Access Compliance Report

Public Rights-of-Way

(Curb Ramps)

Intersection ID: 10025333	Main Street: E_6TH_ST	Cross Street: N/A	Location: E
ADA ID: D522CF89321B	Ramp Type: Perp	Initial Pass/Fail: Pass	Overall Compliance: No
Severity Score: 0			
Codes/Mitigation Info/Possible Solution		Field Measurements/Component Compliance

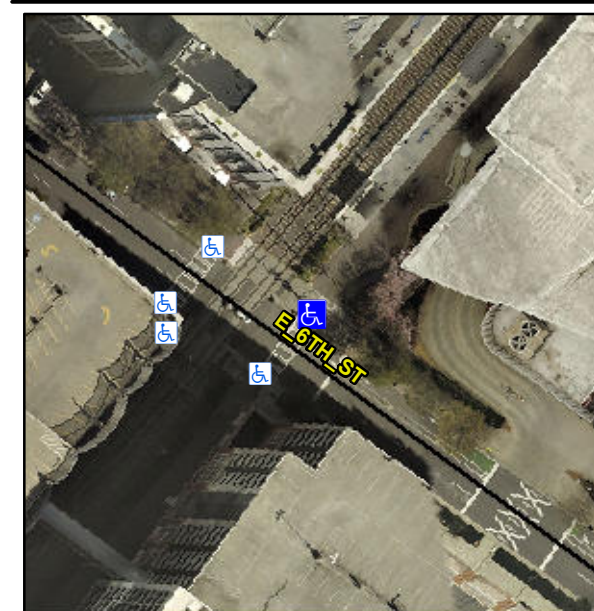
Not Found, R304.2.2-Perp, R304.3.2-Para, R305.2

Compliance	Description	Data	Compliance	Description	Data
N/A	Ramp Length (in)	72.0	Yes	Ramp Slope (%)	6.6
Yes	Ramp Width (in)	48.0	Yes	Ramp XSlope (%)	0.0
N/A	Flare Type LT	Sloped	N/A	Flare Type RT	N/A
N/A	Flare Slope LT (%)	3.7	Yes	Flare Slope RT (%)	3.9
N/A	Flare Traversable LT?	Yes	N/A	Flare Traversable RT?	Yes
Yes	Landing Length (in)	48.0	Yes	DWS Provided?	Yes
Yes	Landing Width (in)	48.0	Yes	DWS Contrast?	Yes
No	Landing Slope (%)	2.7	Yes	DWS Length (in)	24.0
Yes	Landing X Slope (%)	1.9	Yes	DWS Full Width?	Yes
N/A	Landing Curb? (Y/N)	No	No	DWS Offset (in)	4.0
N/A	Shared Landing?	No			
Yes	Gutter Ponding?	No	Yes	Gutter Slope (%)	1.8
Yes	Gutter Lip Ht (in)	0.0	Yes	Gutter X Slope (%)	1.6
N/A	Painted X Walk1?	Yes	N/A	Painted X Walk2?	N/A
	X Walk 1 Direction	To SW		X Walk 2 Direction	N/A
N/A	X Walk 1 Width (in)	109.0	N/A	X Walk 2 Width (in)	N/A
	X Walk 1 Slope (%)	0.9		X Walk 2 Slope (%)	N/A
	X Walk 1 X Slope (%)	0.6		X Walk 2 X Slope (%)	N/A

Yes	Ramp inside XWalk1?	Yes	N/A	Ramp inside XWalk2?	N/A
	Road Slope (%)	N/A	N/A	Clear Space?	Yes
	Road X Slope (%)	N/A	N/A	Clear Space to XWalk (in)	N/A
Yes	Any Obstructions?	No	Yes	Storm Grate/Utility Hazard?	No
	Obstruction Type			Storm Grate/Utility Type	
		N/A			N/A
			Yes	Surface Condition? (G/P)	Good

Remove & Replace Entire Ramp.
